Date: October 21, 2002
 To: T10 Technical Committee
 From: Alvin Cox (alvin.cox@seagate.com)
 Subject: SAS Test Loads

The following changes to text and test load figure are made to aid the testing process by clarifying and defining the compliance channel test load and zero-length test load. The changes to the rev 0 version are significant and not highlighted in an effort to make this version more readable.

Figure 39 — Test Transmitter test loads

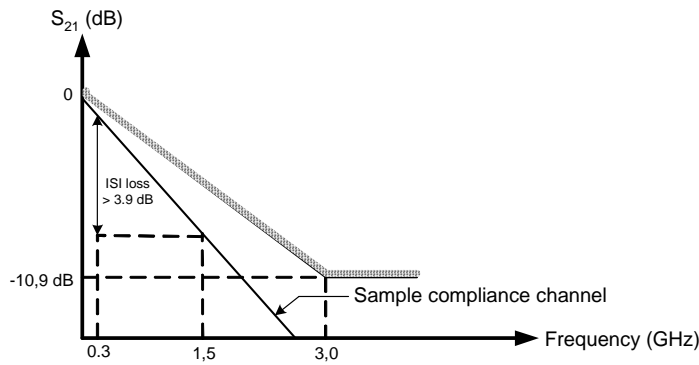
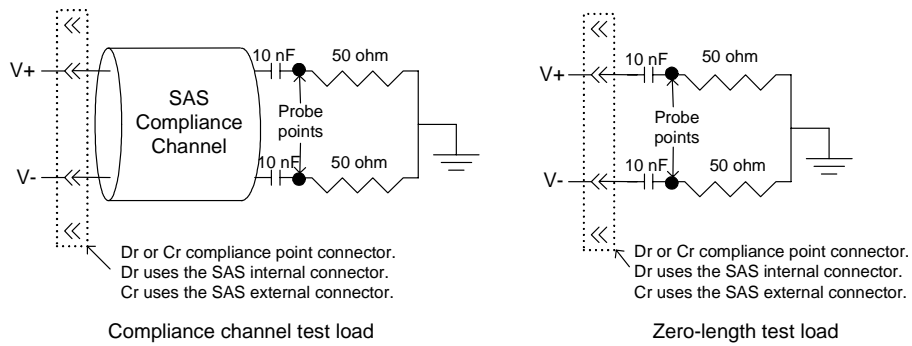
The driver shall have the output voltages and timing listed in table 24 25 and table 26 measured at the designated interoperability points. The default mask is Cr for inter-cabinet TxRx connections and Dr for intra-cabinet TxRx connections. The measurements shall be made across a load equivalent to the zero-length load that shown in figure 39 unless otherwise specified.

The driver shall also meet the output voltages and timing listed in table 25 and table 26 at the designated interoperability points. The default mask is Cr for inter-cabinet TxRx connections and Dr for the intra-cabinet TxRx connections. The measurements shall be made across a load equivalent to the compliance channel test load shown if figure 39 unless otherwise specified. The transmission magnitude response, $[S_{21}]$, of the compliance channel in dB satisfies the following equation:

$$|S_{21}| \leq -20 \log(e) \{ [6.5 \times 10^{-6} (f^{0.5})] + [2.0 \times 10^{-10} (f)] + [3.3 \times 10^{-20} (f^2)] \} \text{ dB}$$

A compliance channel magnitude response and ISI loss example for 3 Gbps is shown in figure 39.
